Project Name: Seaforth Estates Subdivision Parcel 91403

Location: Seaforth Road, Chatham County

Subject Features: One (1) ephemeral stream, three (3) intermittent streams, and one (1) perennial stream

Explanation:

Exhibit 2

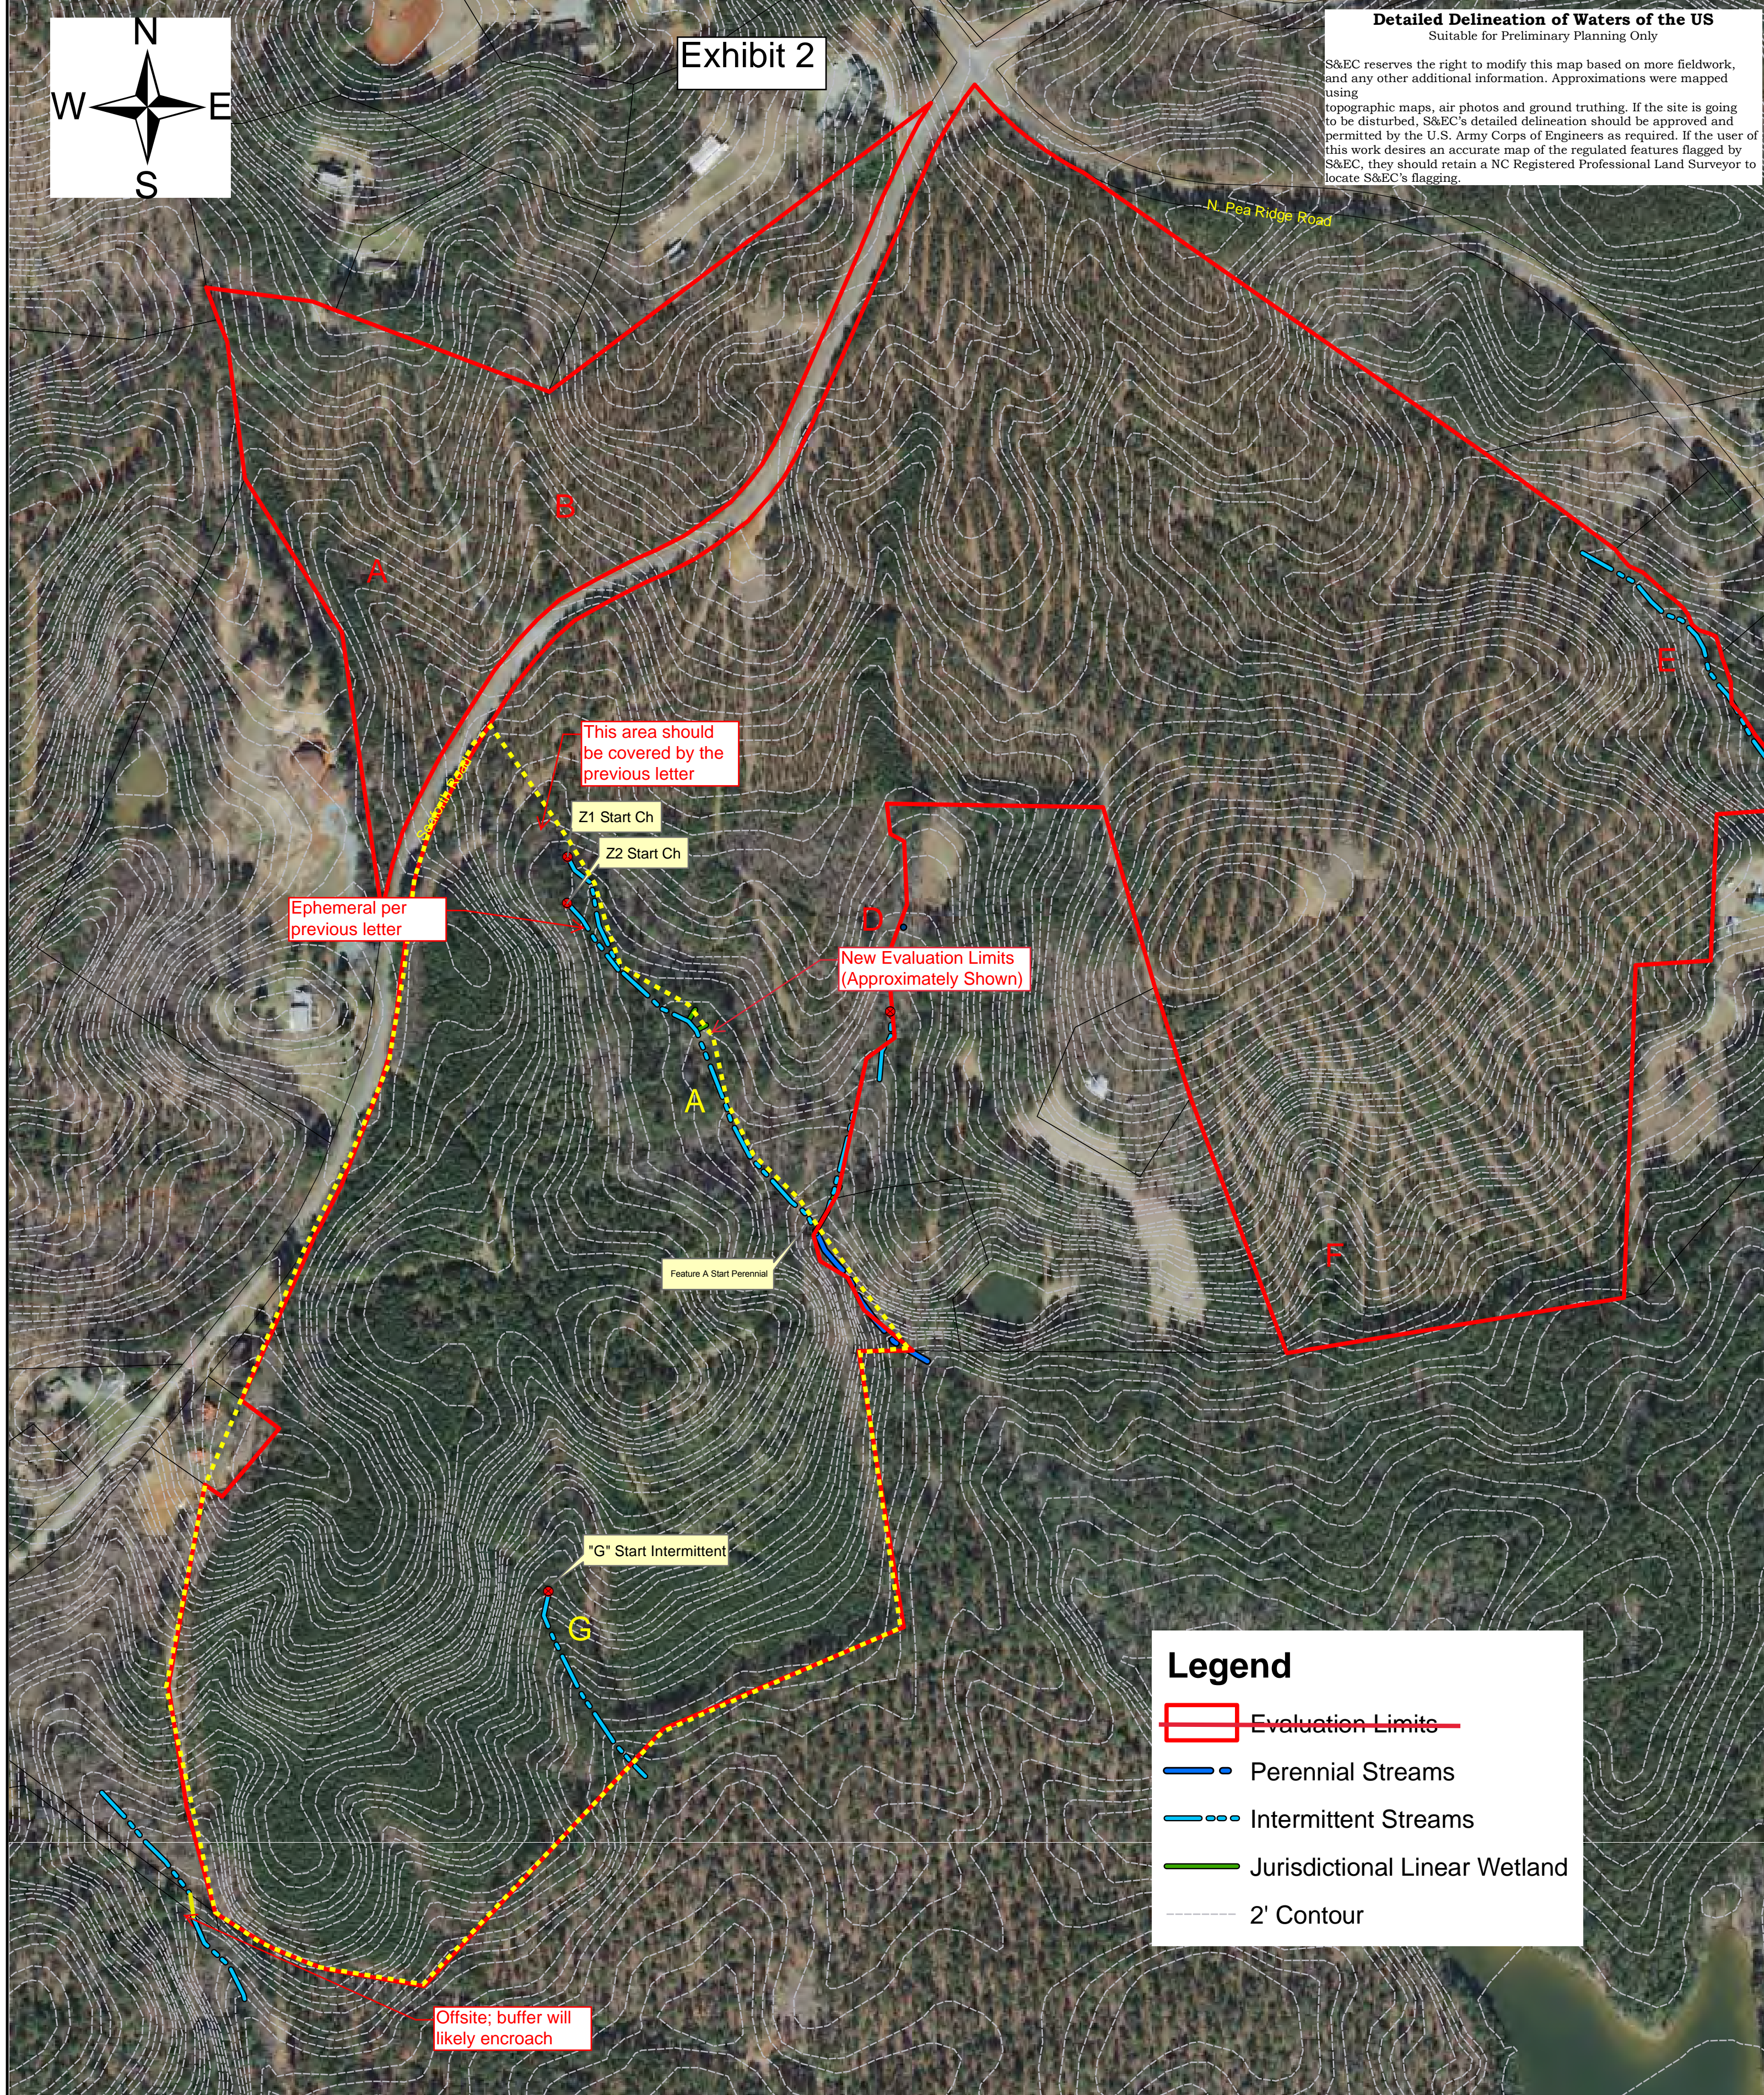
Stream Feature G is the only new feature that was determined to be subject to intermittent riparian buffers of 50-ft from the top bank landward on both side of the feature. The previously determined riparian buffers for the previously reviewed features will remain the same and will apply to this portion of the project.

Ephemeral per previous letter

This area should be covered by the previous letter

"G" Start Intermittent

Offsite; buffer will likely encroach
